STAFF REPORT

Review of Modesto Irrigation District 2024 Integrated Resource Plan

June 2025 | CEC-200-2025-013

Figure 2: MID's Total Net Energy for Load and Forecasted Peak Demand

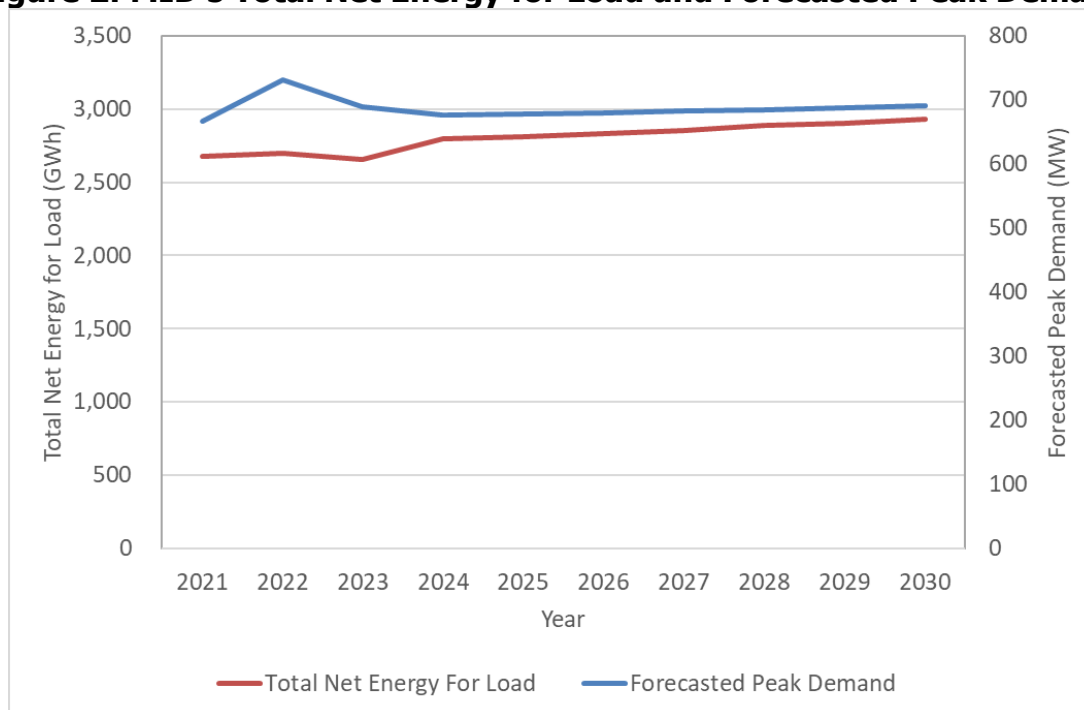
The total net energy for load forecast has a compound annual growth rate of 0.56 percent from 2023 to 2030, which has slightly increased from the annual energy growth rate of 0.43 percent from 2013 to 2022. Figure 2 shows the forecasted total net energy for load from MID's modeling framework, which indicate a value of 2,933 GWh in the year 2030. By contrast, the CEC's forecast of energy requirements for MID is 2,967 GWh, which is comparable.

The 1-in-2 peak demand forecast has a compound annual growth rate of 0.51 percent from 2023 to 2030, which is a slight drop from the 1.6 percent annual growth rate between 2013 and 2022. By 2030, light duty plug-in electric vehicles (EVs) are expected to contribute 18 MW to the 1-in-2 peak demand. However, customer-side solar is expected to output 45 MW by 2030. MID's solar forecast model could be predicting customer-side generation that offsets the demand generated by the growth of EVs in MID's territory leading to this reduced growth rate. The CEC Energy Demand 2023-2040 Forecast – Planning Forecast 1-in-2 Net Electricity Peak Demand, projects 736 MW peak demand for MID in 2030, which is higher than the *MID 2024 IRP* forecast of approximately 692 MW as seen in Figure 2. This discrepancy could be attributed to the differences in how the CEC and MID calculate and incorporate Additional Achievable Energy Efficiency. The CEC planning forecast also incorporates Additional Achievable Fuel Substitution and Additional Achievable Transportation Electrification. MID's forecasting incorporates a machine solar forecast model that projects distributed solar generation to offset 191.7 GWh of system energy consumption annually by the end of 2030.

2006 to 2022)⁹. After ranking the forecast results from the weather scenario sets from highest to lowest, the 50th percentile result was selected as the annual peak value. By contrast, the CEC’s forecast takes into account weather variables that are informed by climate projections. This could be another possible reason for the discrepancy between the CEC and MID forecasts.
